Underground Storage Tank System Inspection Report

Bulk Fuel Storage Systems Including Red Hill and the Airport Hydrant System Serving Joint Base Pearl Harbor-Hickam

August 17, 2022

US EPA REGION 9 UNDERGROUND STORAGE TANK INSPECTION REPORT

Figure 1: Main Containment Sump for Fuel Oil Reclamation

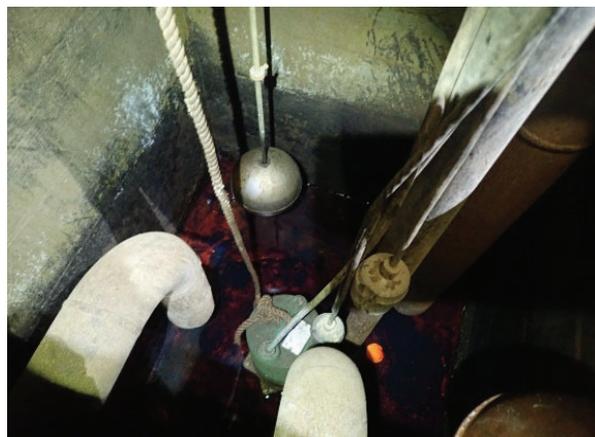
The UST inspection team identified two sumps in the lower tunnel (Main Containment Sump for Fuel Oil Reclamation and Zone 7 Sump for Fuel Oil Reclamation), see photos below, that were not included in the Navy's May 15, 2019, UST permit application submitted to HDOH (Attachment K). These sumps meet the definition of a "Tank," because they are stationary devices designed to contain an accumulation of regulated substances and constructed of non-earthen materials (e.g., concrete, steel, plastic) that provide structural support, per HAR § 11-280.1-12. The volumetric capacities of the two sumps were undetermined at the time of the inspection. The Navy was unable to demonstrate that these two USTs were in compliance with the tank tightness testing and other UST requirements.
